Urban Planning and Land Use

To: City Planning Commission
From: City Staff
Date: July 8, 2019
Re: Petition #PR-2019-12

Requested Action:
Approval of Final Plan Review

Purpose:
To remodel and expand the gas station
and tire shop

PHOTOMETRIC AND LIGHTING PLANS

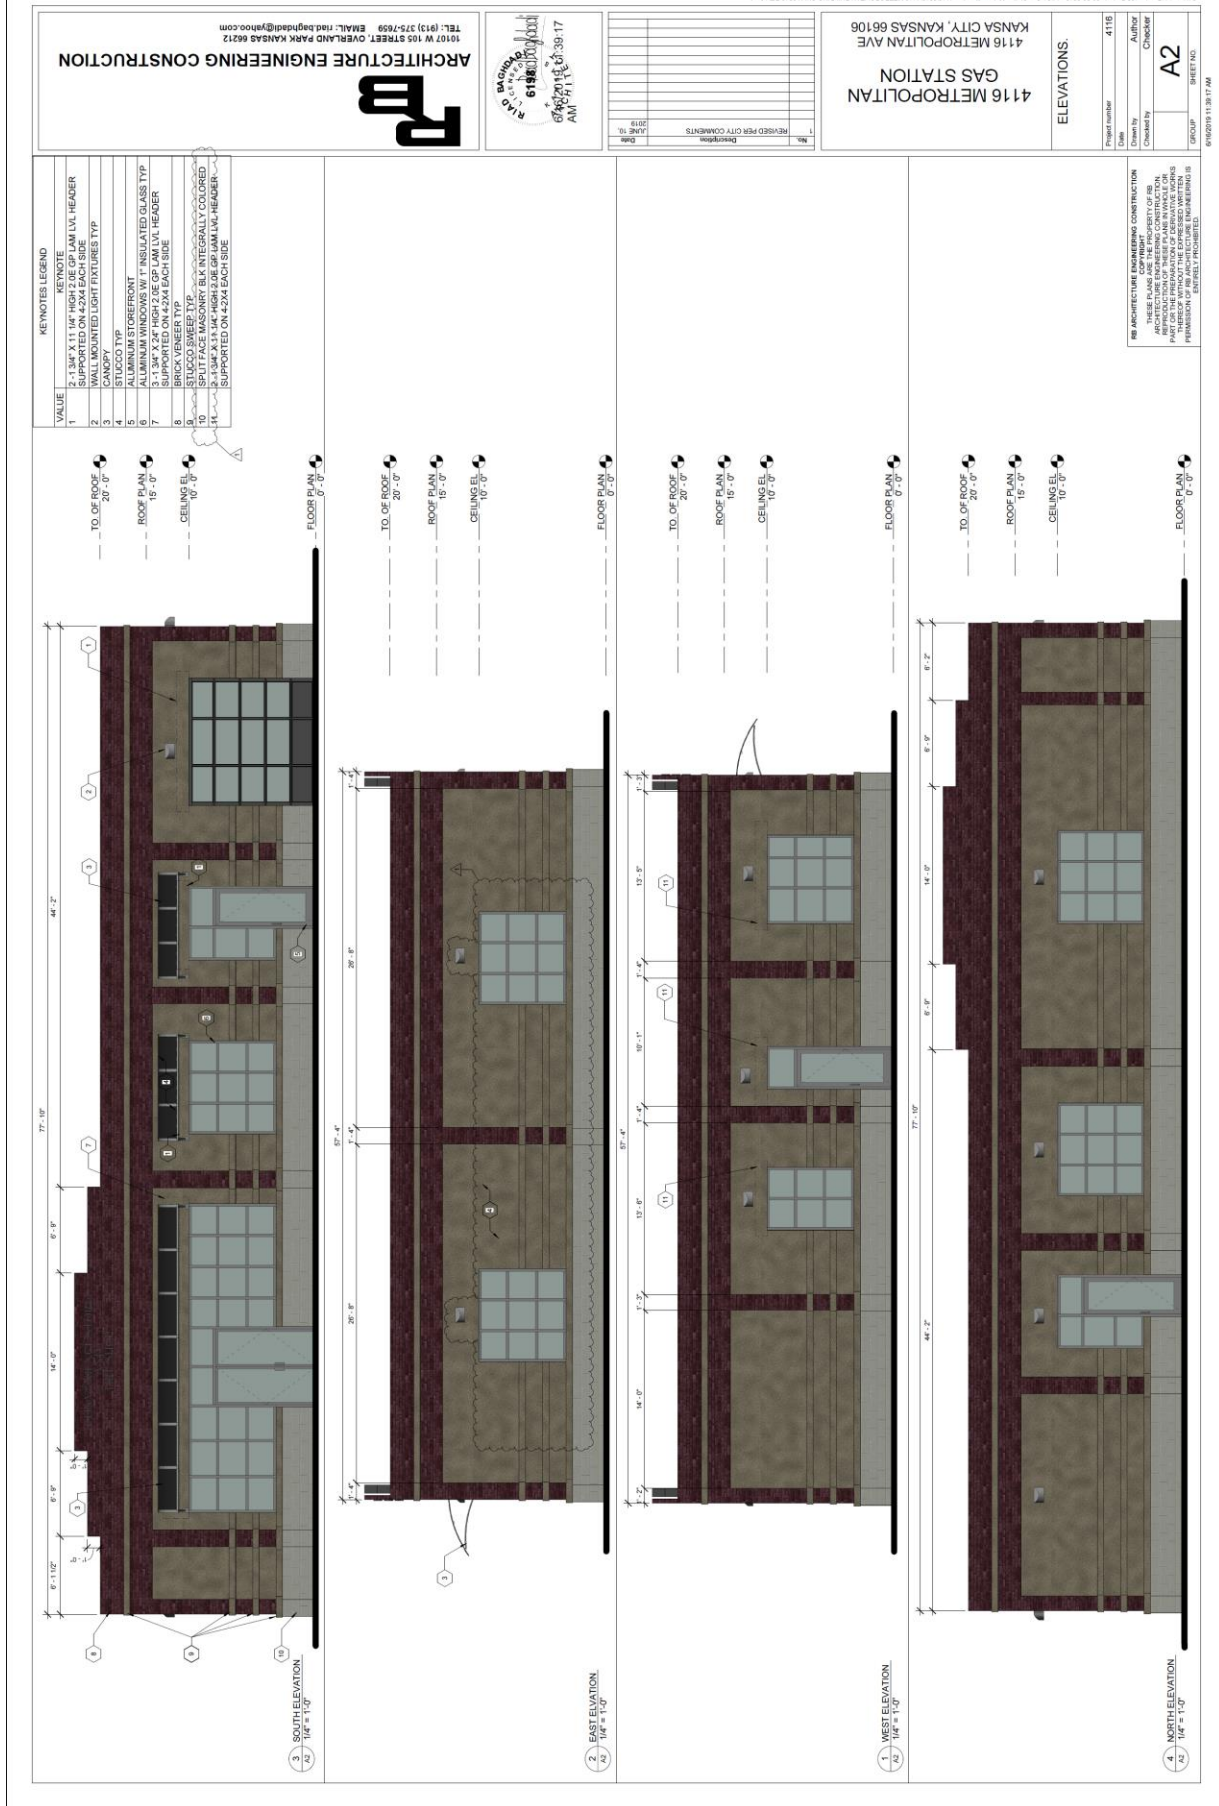
6. All lighting shall have 90-degree cutoff fixtures Any lighting that is physically mounted to the building shall be decorative and have 90-degree cutoffs, as not to cast on adjacent properties and public right-of-way. Light shall not exceed one footcandle as measured from said property line. Wall pack lighting is not permitted.

The photometric plan does not comply with our code, as the proposed lighting exceeds one (1) footcandle maximum at the property line along the perimeter of the property. Please revise accordingly.

Applicant Response: *All lighting will have 90-degree cutoff fixtures. Photometric plan has been revised to limit footcandle along east property to less than one footcandle.*
